# Access Compliance Report

## Public Rights-of-Way

Intersection ID: 14289	Main Street: E_7TH_ST	Cross Street: RIDGEWAY_AV	Location: SW
ADA ID: E0B32BFE834B	Ramp Type: PerpDiag	Initial Pass/Fail: Fail	Overall Compliance: No
Severity Score: 35			
Codes/Mitigation Info/Possible Solution		Field Measurements/Component Compliance

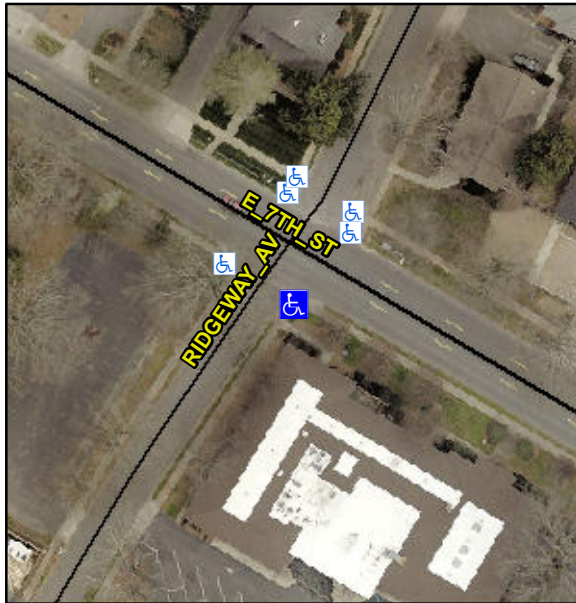
**Not Found, R304.5.1, R304.2.2, R304.5.3**

Compliance	Description	Data	Compliance	Description	Data
N/A	Ramp Length (in)	48.0	No	Ramp Slope (%)	14.0
No	Ramp Width (in)	37.0	No	Ramp XSlope (%)	3.7
N/A	Flare Type LT	N/A	N/A	Flare Type RT	N/A
N/A	Flare Slope LT (%)	N/A	N/A	Flare Slope RT (%)	N/A
N/A	Flare Traversable LT?	N/A	N/A	Flare Traversable RT?	N/A
N/A	Landing Length (in)	N/A	N/A	DWS Provided?	N/A
N/A	Landing Width (in)	N/A	N/A	DWS Contrast?	N/A
N/A	Landing Slope (%)	N/A	N/A	DWS Length (in)	N/A
N/A	Landing X Slope (%)	N/A	N/A	DWS Full Width?	N/A
N/A	Landing Curb? (Y/N)	N/A	N/A	DWS Offset (in)	N/A
N/A	Shared Landing?	N/A			
N/A	Gutter Ponding?	N/A	N/A	Gutter Slope (%)	N/A
N/A	Gutter Lip Ht (in)	N/A	N/A	Gutter X Slope (%)	N/A
N/A	Painted X Walk1?	No	N/A	Painted X Walk2?	No
	X Walk 1 Direction	To NE		X Walk 2 Direction	To NW
N/A	X Walk 1 Width (in)	N/A	N/A	X Walk 2 Width (in)	N/A
	X Walk 1 Slope (%)	1.3		X Walk 2 Slope (%)	0.3
	X Walk 1 X Slope (%)	1.5		X Walk 2 X Slope (%)	1.0

**Remove & Replace Curb Ramp With Two New Directional Ramps or Equivalent.**
